RHODE ISLAND DEPARTMENT OF TRANSPORTATION

I-195 Relocation – Contract 16 – Providence River Pedestrian Bridge

NOTICE TO PROSPECTIVE BIDDERS

ADDENDUM NO. 9 Prospective bidders and all concerned are hereby notified of the following changes in the Plans, Specifications, Proposal and Distribution of Quantities for this contract. These changes shall be incorporated in the Plans, Specifications, Proposal and Distribution of Quantities, and shall become an integral part of the Contract Documents.

IMPROVEMENTS TO INTERSTATE ROUTE 195
 CONTRACT 16 VOLUME 2
 PROVIDENCE RHODE ISLAND
 OVERALL UPPER BRIDGE PLAN
 A101

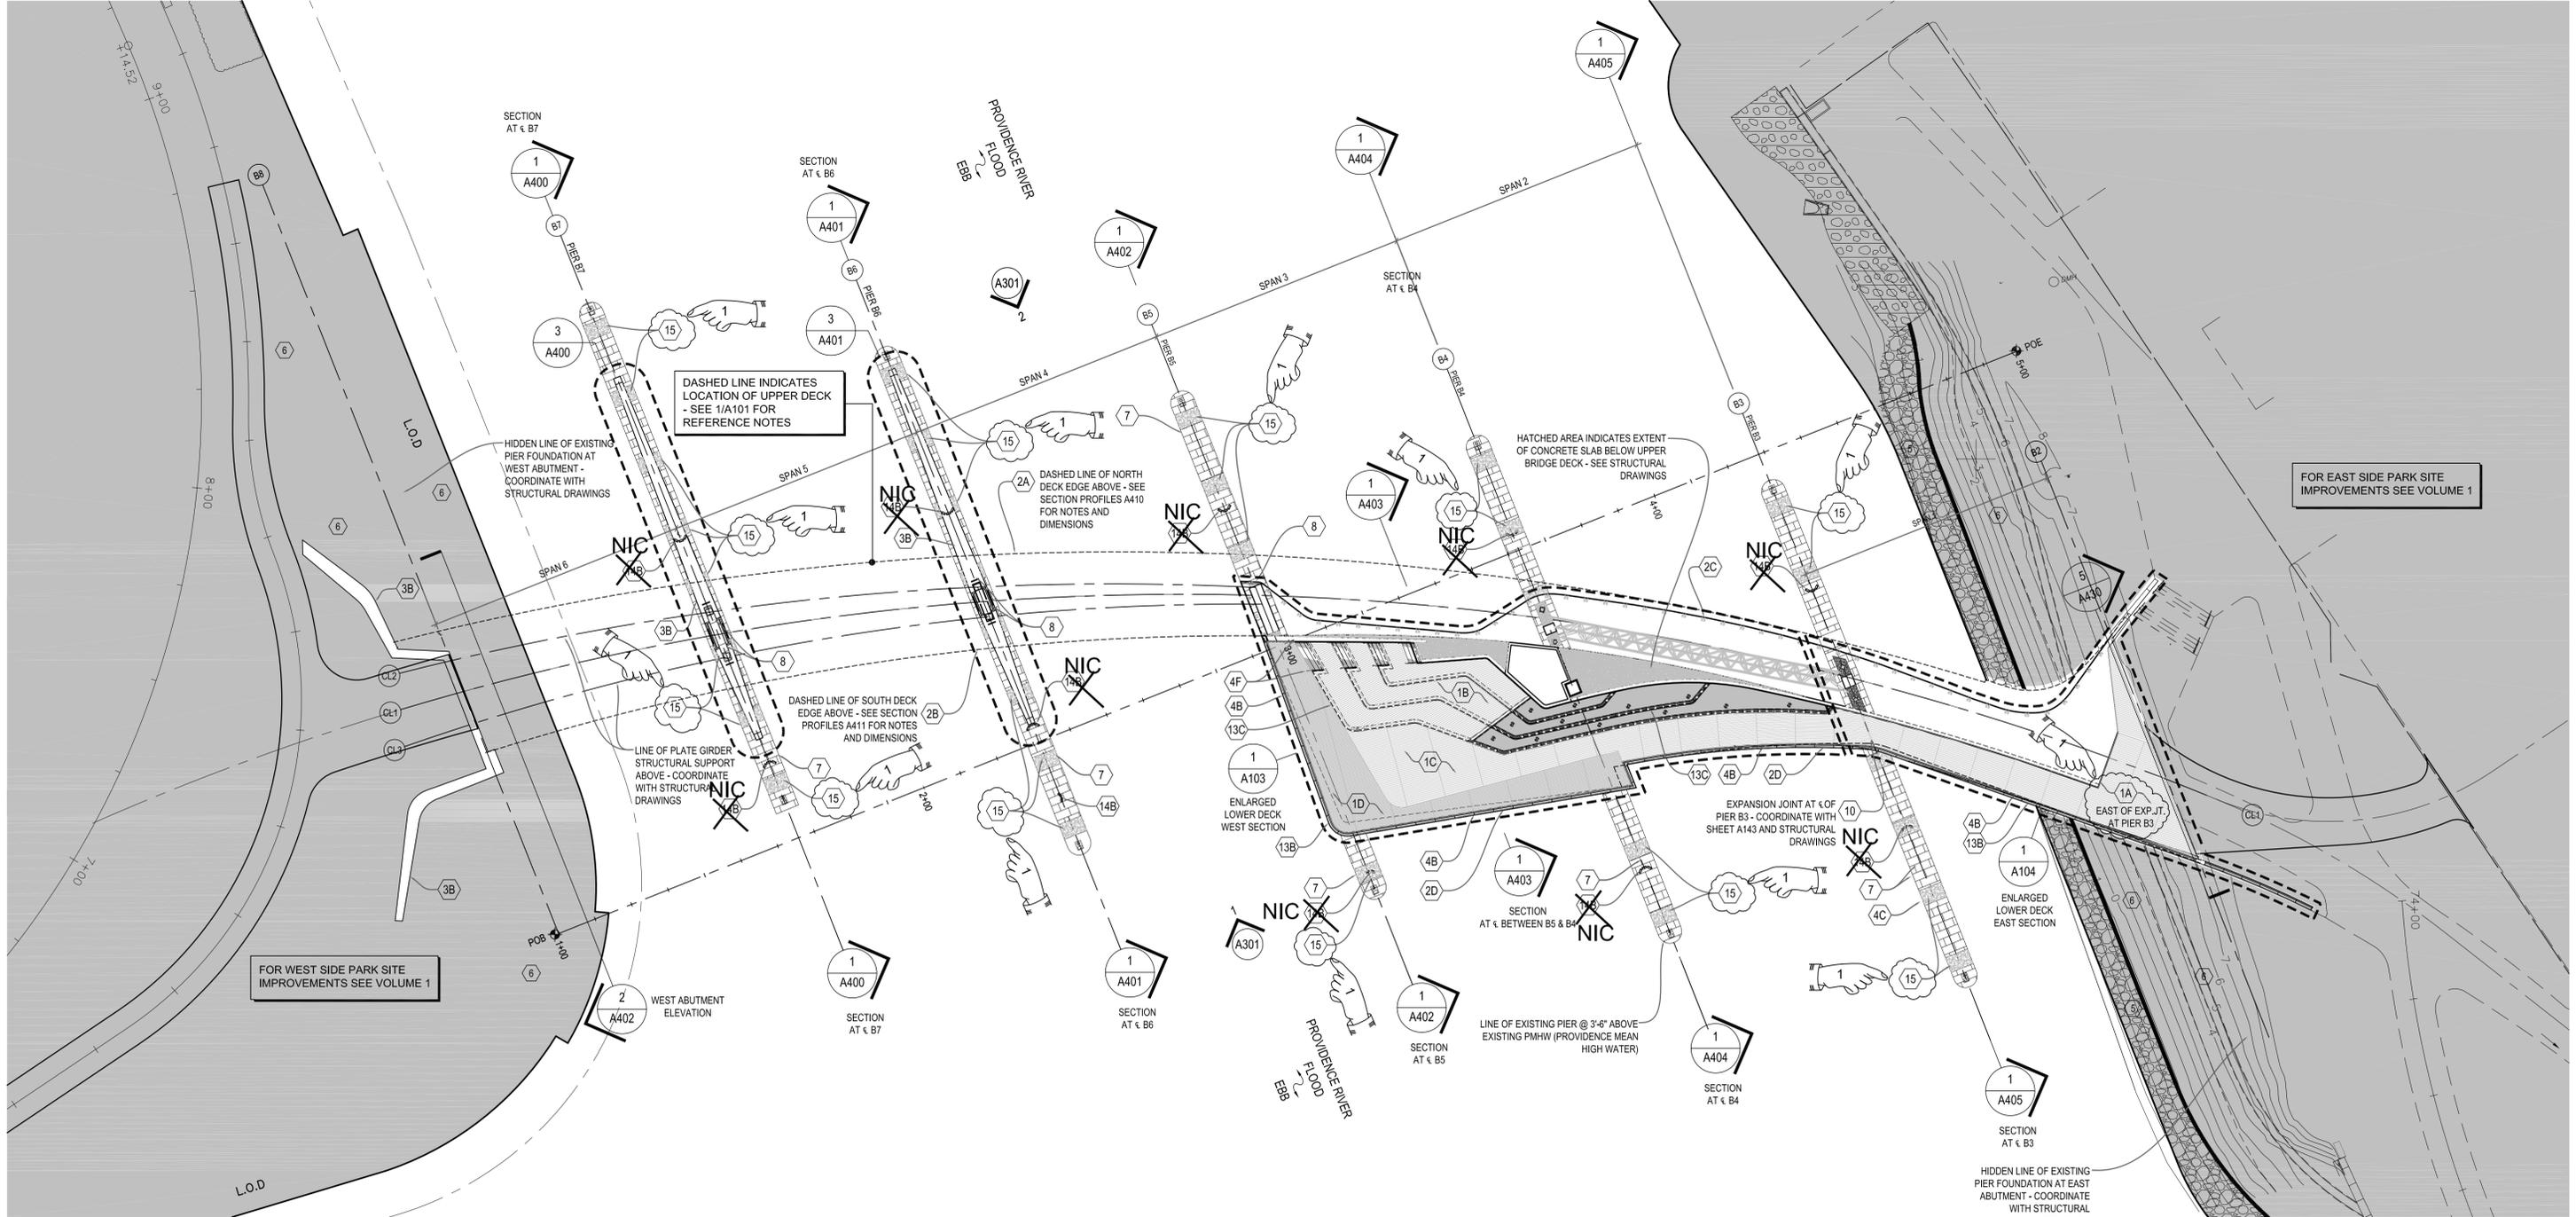
1. Sheet V2_002(R-1)
Delete Sheet V2_002(R-1) in its entirety and replace it with sheet V2_002(R-2) attached to this Addendum No. 9. Locations for Item Code 834.9920 New Granite Cap at Existing Columns are shown on the plan. Pier flood lights have been removed from the Contract.

IMPROVEMENTS TO INTERSTATE ROUTE 195 CONTRACT 16 VOLUME 2	
BRIDGE PLAN - LOWER DECK - WEST	A103

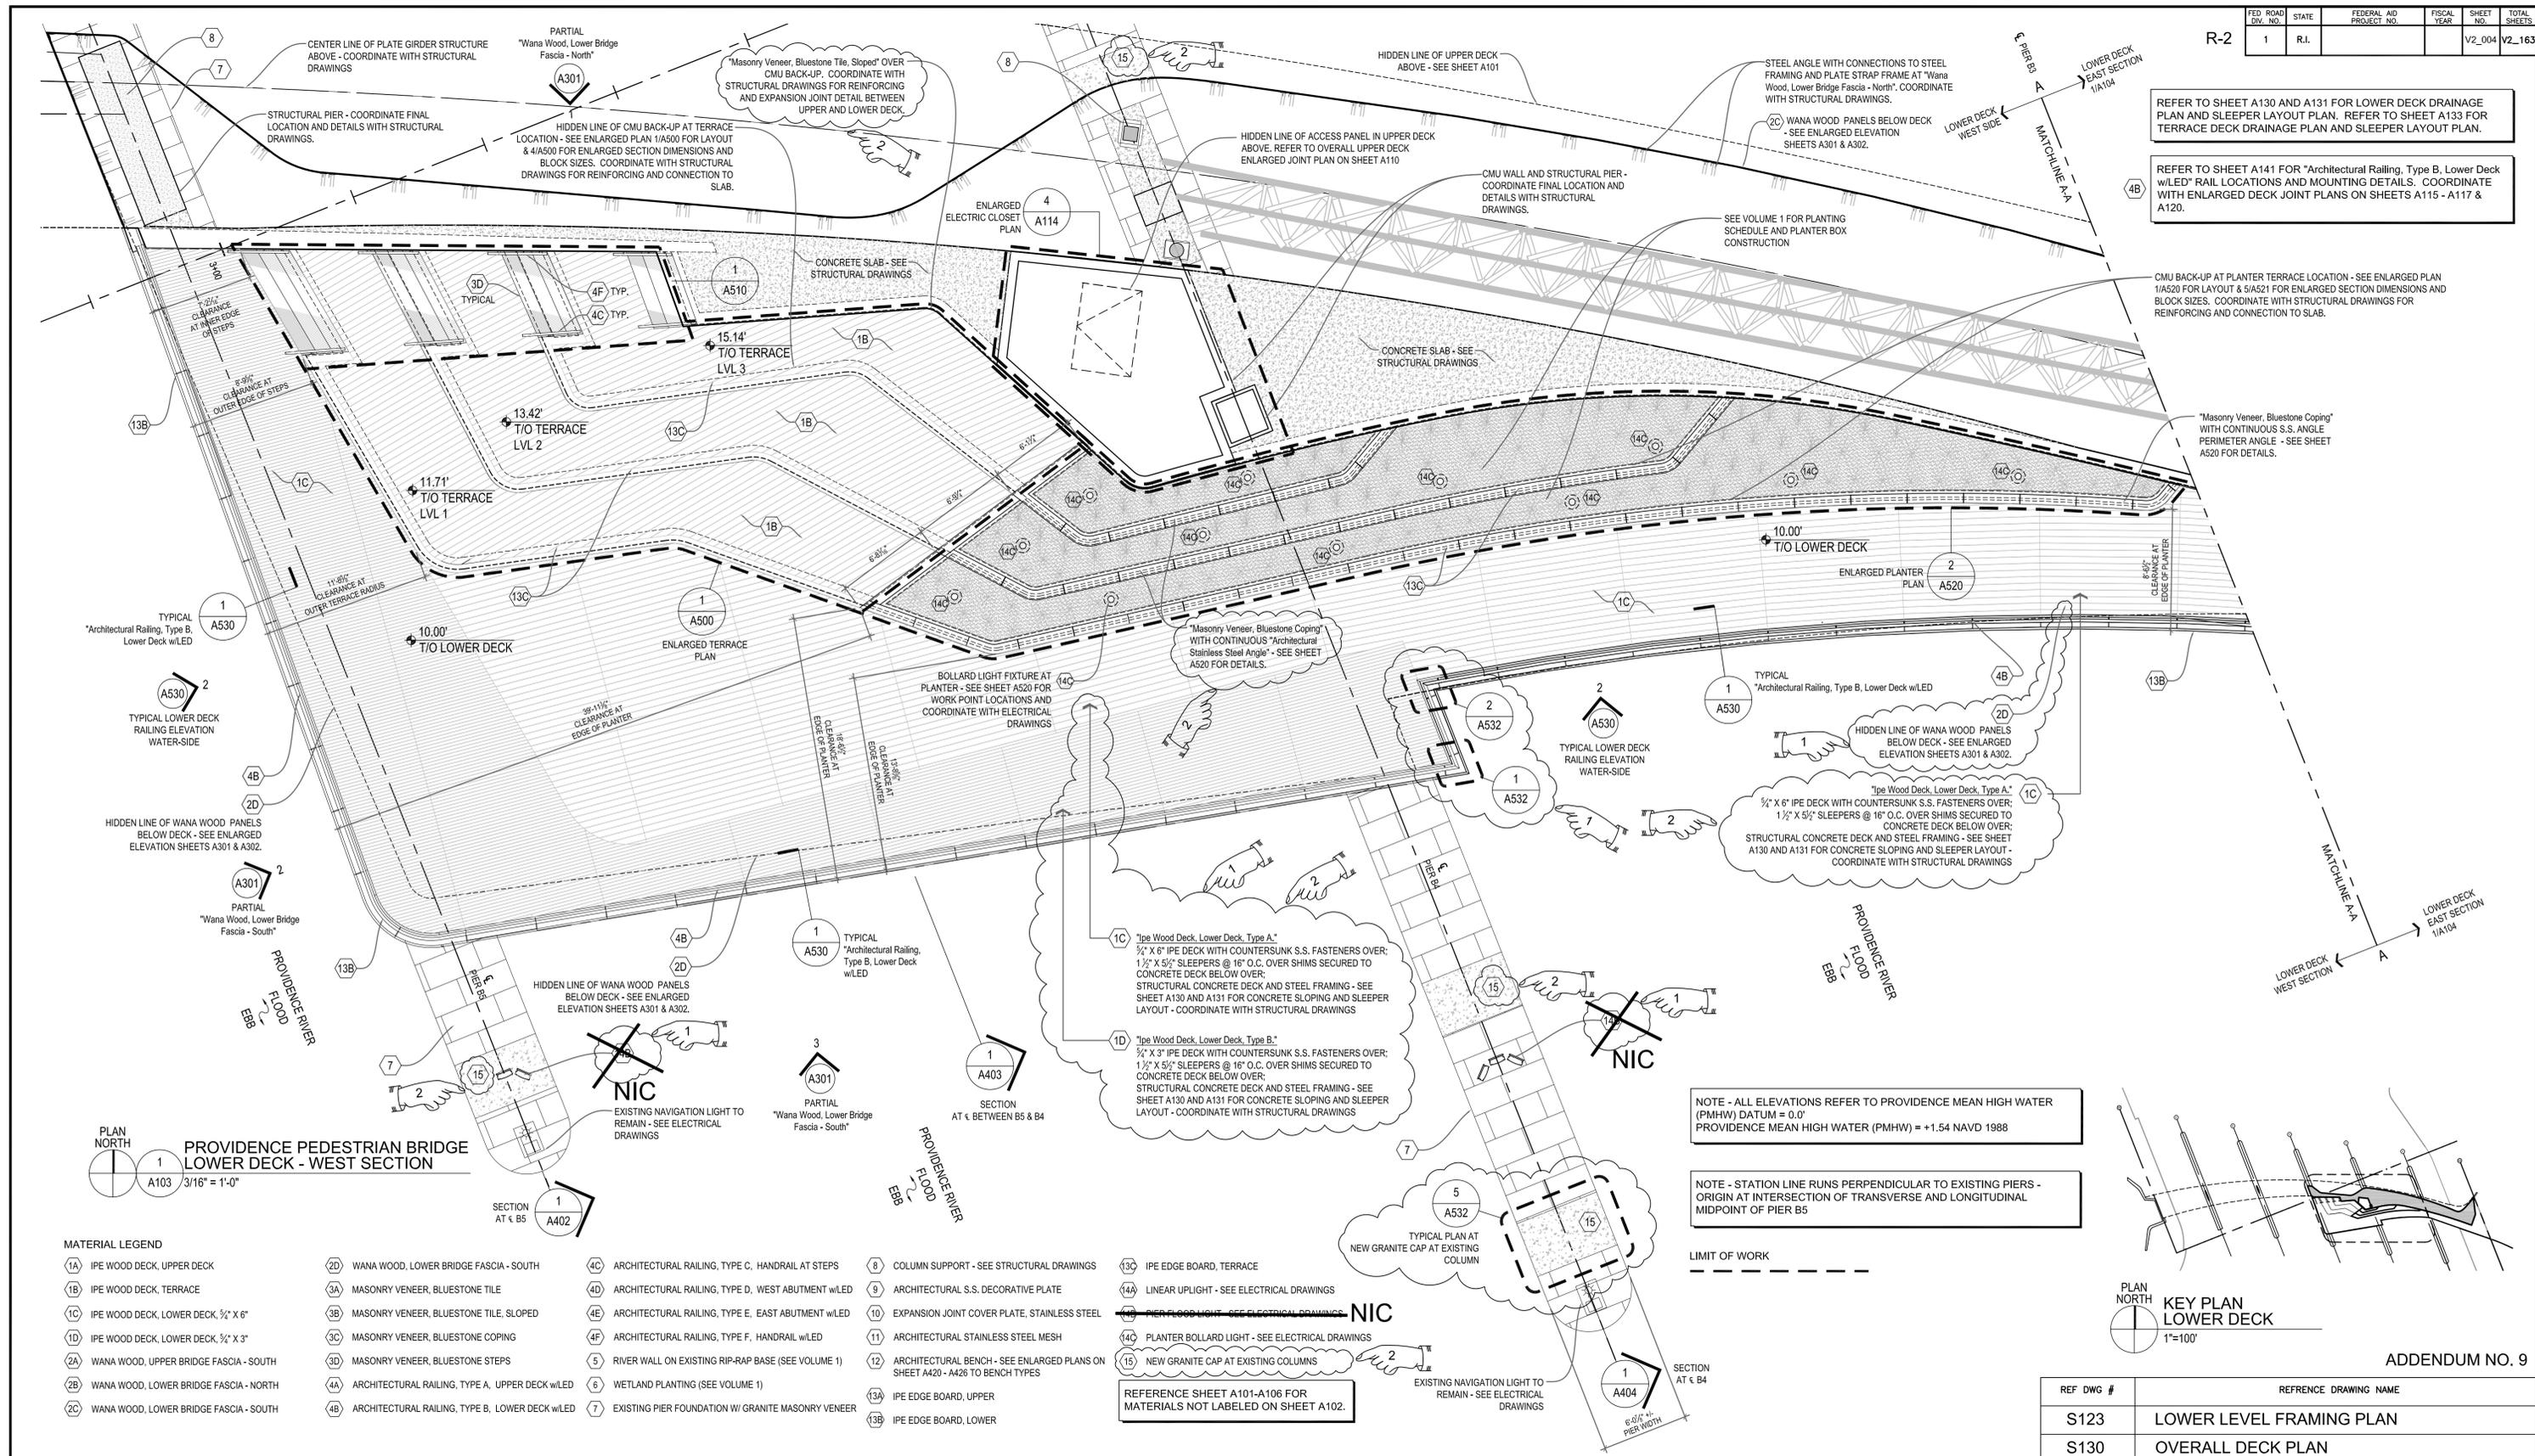
3. Sheet V2_004(R-1)
Delete Sheet V2_004(R-1) in its entirety and replace it with sheet V2_004(R-2) attached to this Addendum No. 9. Locations for Item Code 834.9920 New Granite Cap at Existing Columns are shown on the plan. The requirements for IPE deck hardware have been updated. The callout for masonry veneer has been revised. Pier flood lights have been removed from the Contract.

REFERENCE SHEET A101-A106 FOR MATERIALS NOT LABELED ON SHEET A104.

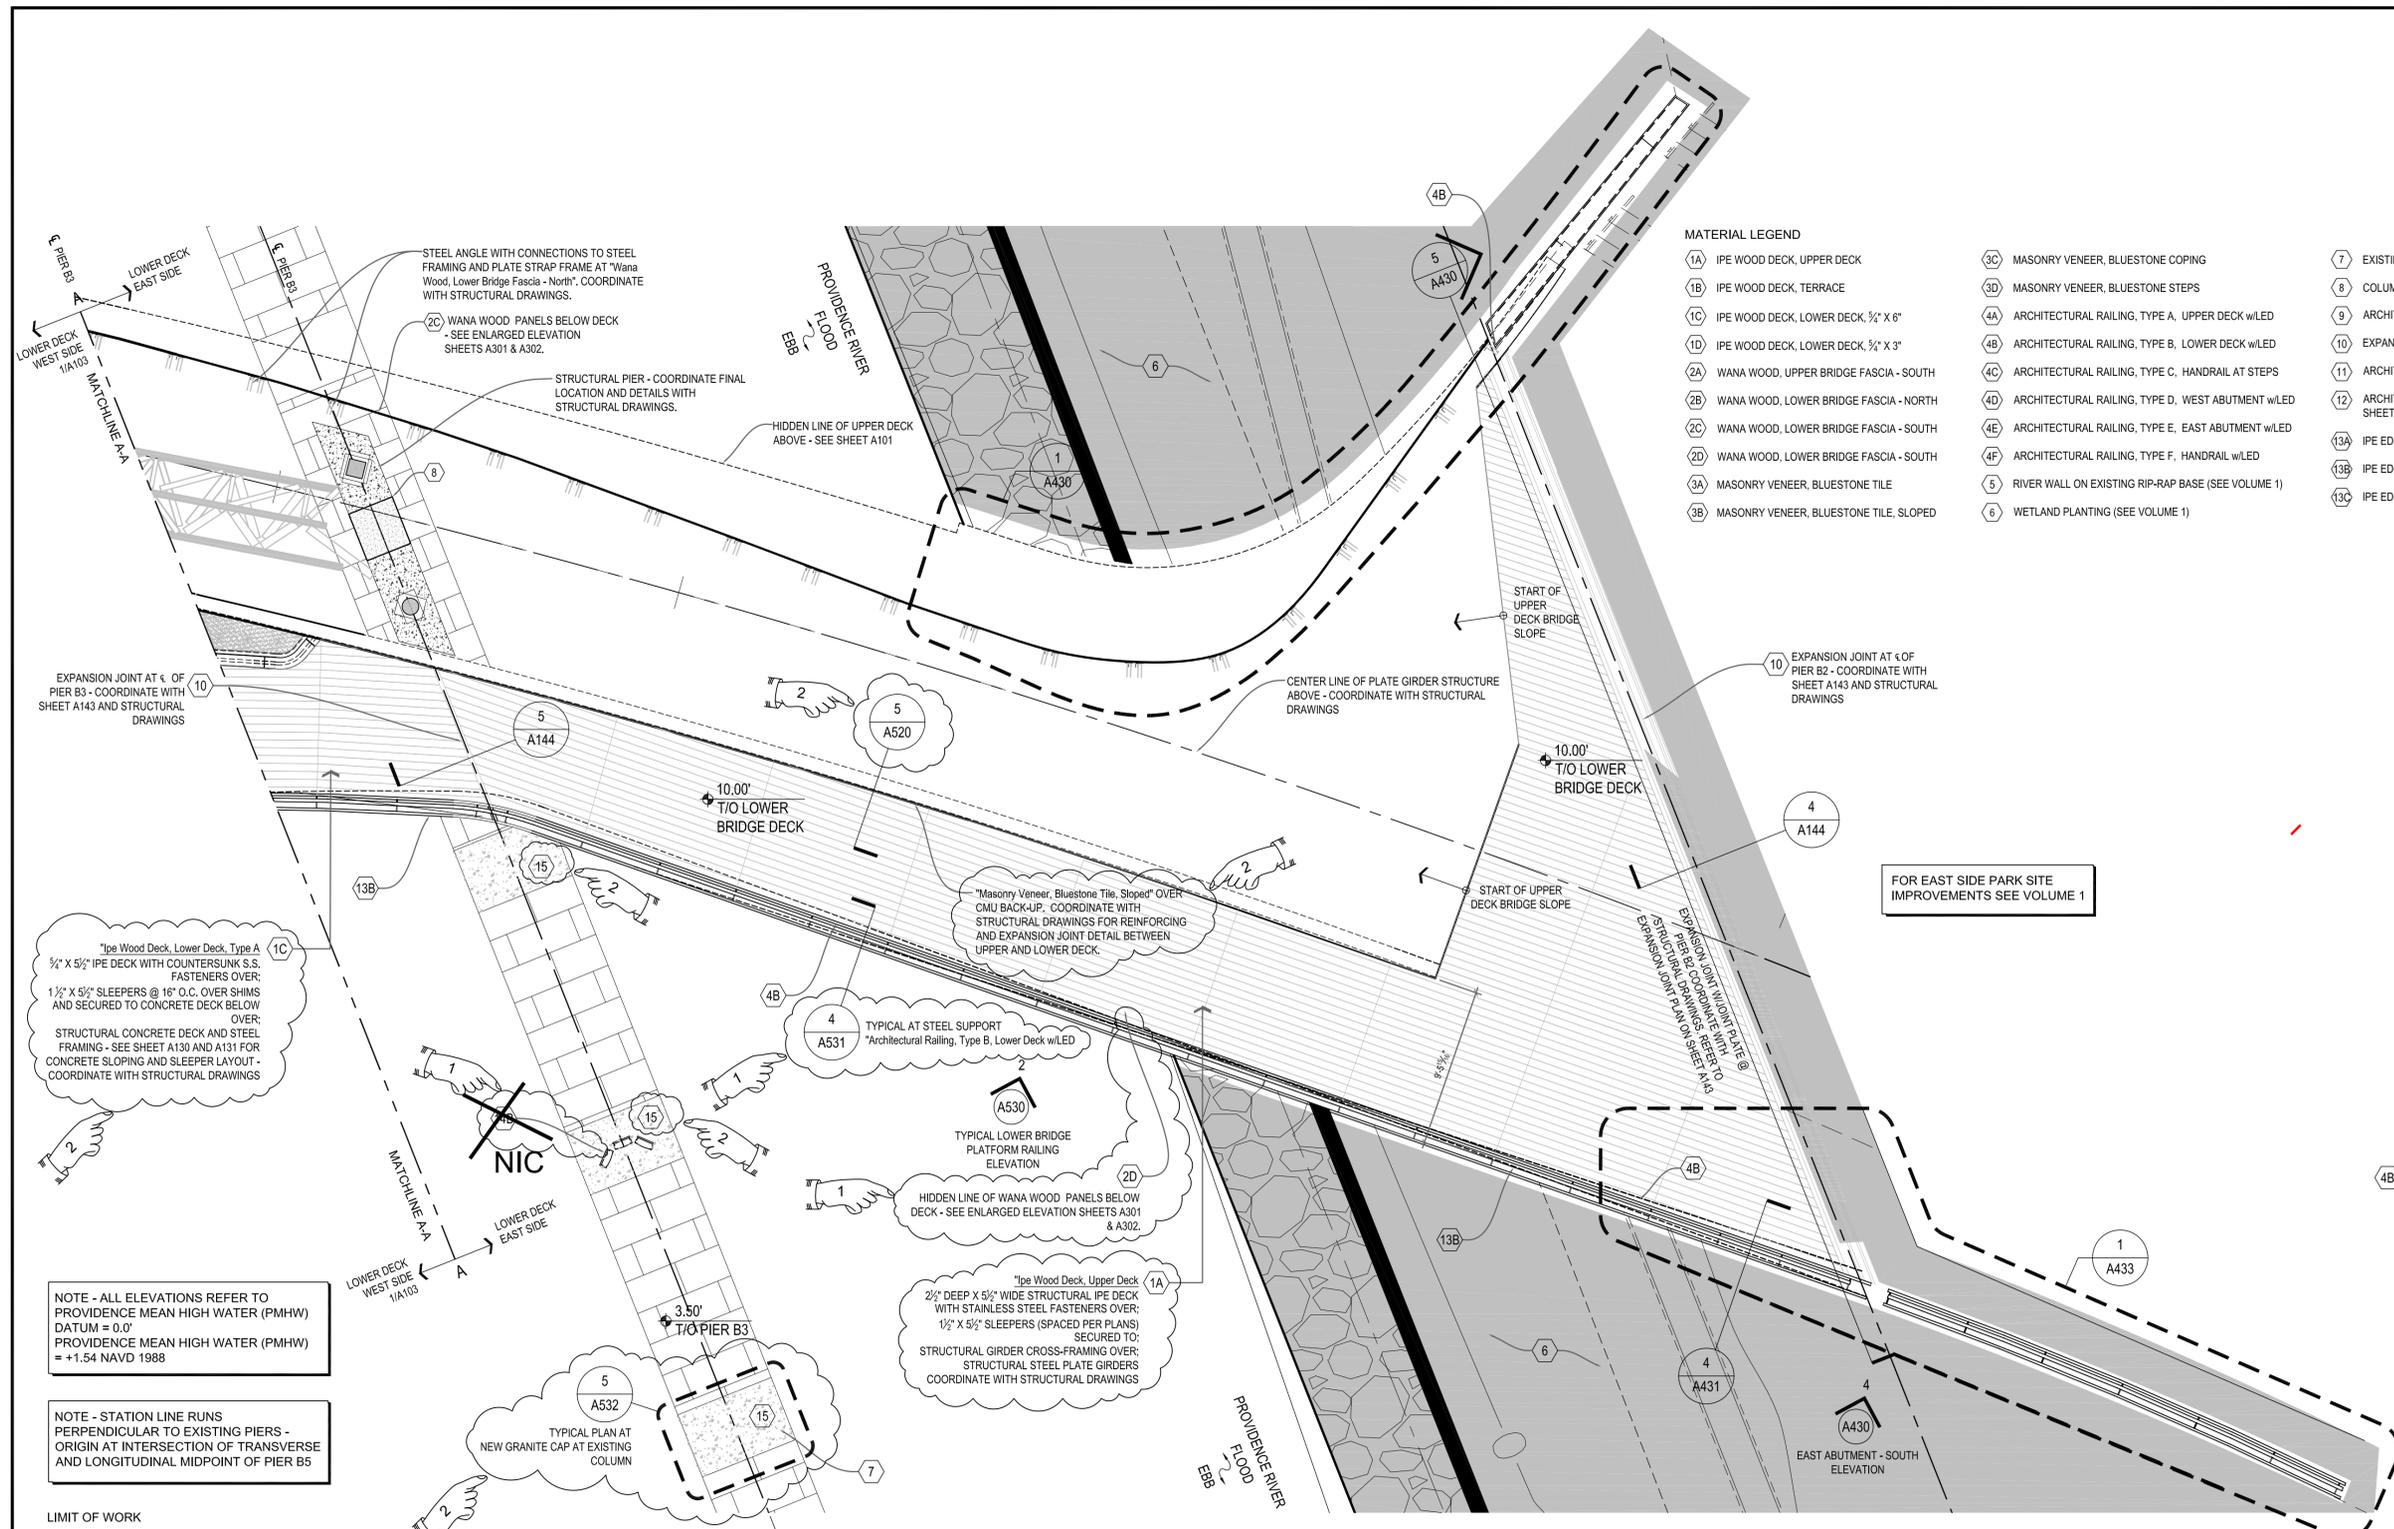
4. Sheet V2_005(R-1)
Delete Sheet V2_005(R-1) in its entirety and replace it with sheet V2_005(R-2) attached to this Addendum No. 9. Locations for Item Code 834.9920 New Granite Cap at Existing Columns are shown on the plan. The requirements for IPE deck hardware have been updated. The callout for masonry veneer has been revised. Pier flood lights have been removed from the Contract.
